**RE: USC Sumter Parking Lot Improvements Phase 1 of 2
For the University of South Carolina
State Project No. H39-9517-MJ-D
URS Project No. 46423239**

ADDENDUM NO. 1 – August 8, 2014

REVISION TO DETAIL 1
ON SHEET C5

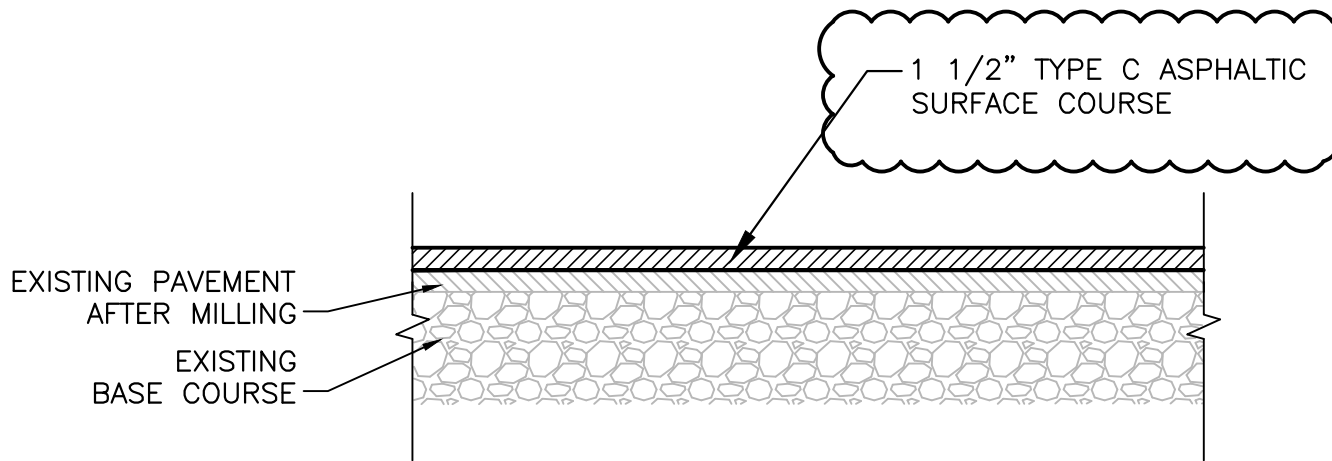
3. **Question:** The existing asphalt is to be milled 1 ½” as per sheet C3. Note # 13 on sheet C4 states that the new asphalt is to be “performed to the existing grades”, but note #6 states that the new asphalt is to be a minimum of 2”. Please clarify.

4. **Question:** The asphalt pavement detail shown on sheet C5 shows 6” base material and 2” asphalt. The areas shown on sheet C4 that are heavily shaded are designated at full depth asphalt. Since these areas are so small, working the base material with equipment is almost impossible. Can full depth asphalt be used?

5. **Question:** The asphalt pavement detail shows the surface to be Type B. Type B has large aggregate in it and does not lend itself to be worked by hand, as would be necessary in the corners. Can Type C be used?

Answer: *Strike Note 6 on sheet C3. The minimum resurfacing thickness, after compaction, shall be 1.5 inches. Please see attached revised Detail 1 and Detail 3 for sheet C5.*

Answer: *Yes, please see attached revised Detail 1 and Detail 3 for sheet C5.*

Answer: *Type C shall be utilized. Please see attached revised Detail 1 and Detail 3 for sheet C5.*
